SERVICE BULLETIN

Classification: BT22-007	Reference: NTB22-068	Date: August 2, 2022
-----------------------------	-------------------------	-------------------------

WATER LEAKING FROM REAR WIPER ARM PIVOT SEAL

APPLIED VEHICLES: 2021-2022 Rogue (T33)

Figure 1

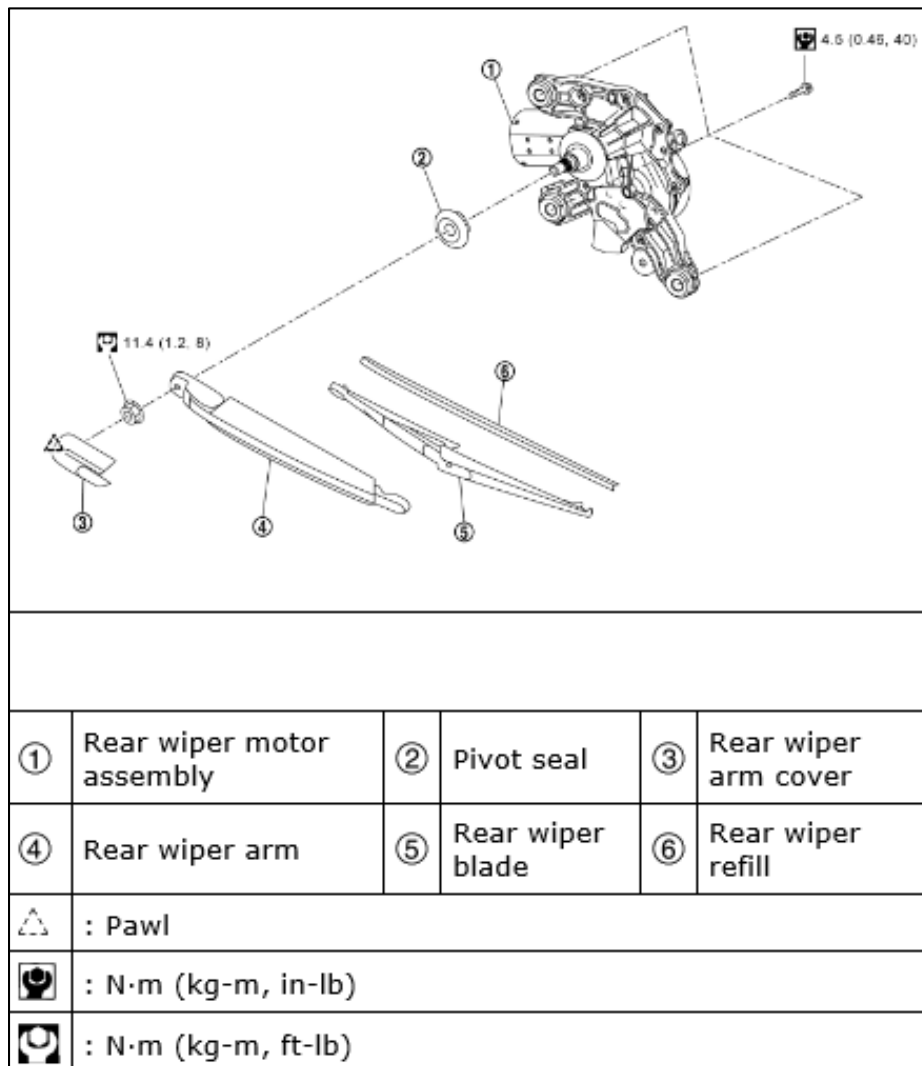
Water is found to be leaking around the rear window wiper arm pivot seal after performing a water soak test.

1. Replace the rear wiper arm pivot seal (#2 in Figure 1).
 - Refer to the ESM: **DRIVER CONTROLS > WIPER & WASHER > REMOVAL AND INSTALLATION > REAR WIPER > WIPER MOTOR**

Replace the rear window wiper arm pivot seal with the one listed in **PARTS INFORMATION** on page 3.
